AMENDED
Truro Planning Board Agenda
Remote Zoom Meeting
Wednesday, January 24, 2024 – 5:00 pm
www.truro-ma.gov

Preliminary Subdivision Plan, 9B Benson Road, Fisher Road Realty Trust, Gloria J. Cater and Willie J. Cater, Trustees

To: Barbara Carboni
From: Cape Cod Commission Staff
Date: January 23, 2024
Re: 9B Benson Road, Truro – Technical Assistance Request

PLAN VIEW
ACCESS RIGHT OF WAY IMPROVEMENTS
SCALE: HORIZONTAL 1"=40'

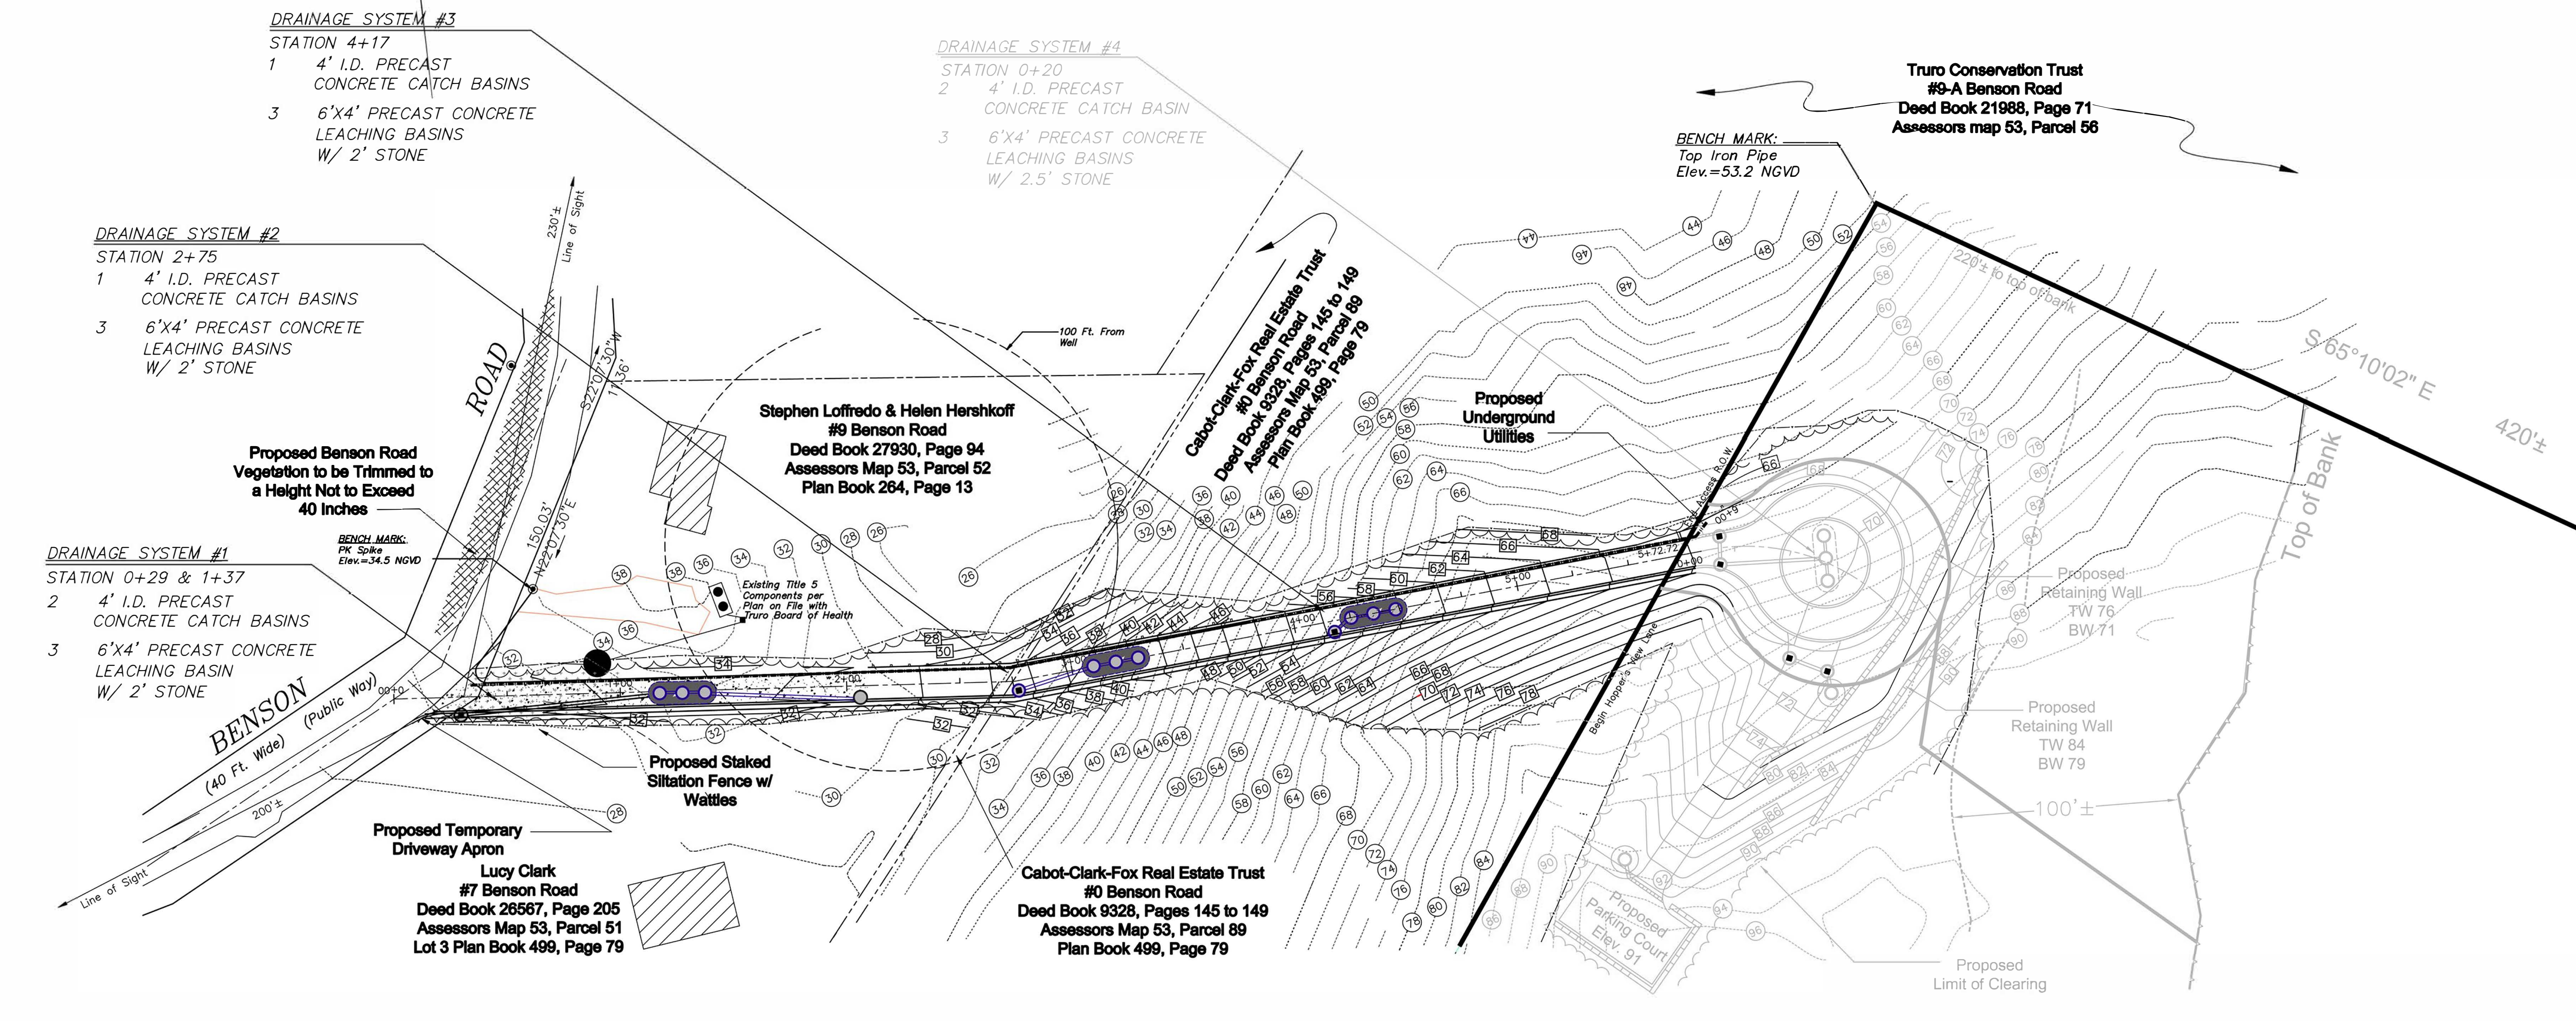
There are some discrepancies between the plan view and the associated profile drawings, such as the number of catch basins and leaching pits. It is not clear if the 9% slope plan proposes 2 or 3 leaching pits, but 3 are recommended. There are also inconsistencies between the legend key and the symbols used on the plans. Lastly, key information is missing that is needed to make a confident assessment of the functionality of the stormwater management systems for either of the proposed alternatives, such as drainage calculations and quantity (square feet) of impervious surface.

That aside and in terms of stormwater management the proposed access roadway with a 9% slope is slightly preferred for a number of reasons, but primarily because the slope is less extreme. The alternative with the 14% slope is nearly at the maximum slope considered safe for travel. However, there are several concerns with the 9% alternative as it is proposed.

Regardless of whether the driveway has a slope of 9 or 14%, most of the stormwater runoff will not enter the catch basins that are located on the slope, as it is too steep. Most of the runoff will run over or around the catch basins. Other stormwater management systems could be considered for the steeply sloped section of the driveway that would likely provide better stormwater management. For example, water bars constructed diagonally across the road directing runoff to sheet-flow over the sides of the road (country drainage, no berm) to vegetated swales (possibly also with water bars or ridges) alongside the road. Water bars (or ridges), which act to slow and direct runoff, can be designed in such a way as to allow cars to drive over them.

Alternatively, if berms are required due to the extreme slope of the driveway, water bars or ridges could be used to direct stormwater runoff to the catch basins. It might also be worth considering a trench drainage system at the bottom of the sloped section; or two catch basins on each side of the road (if road is crowned) at the base of the slope (total of 4 catch basins). These may prove to be better options than multiple catch basins located along the extremely sloped section.
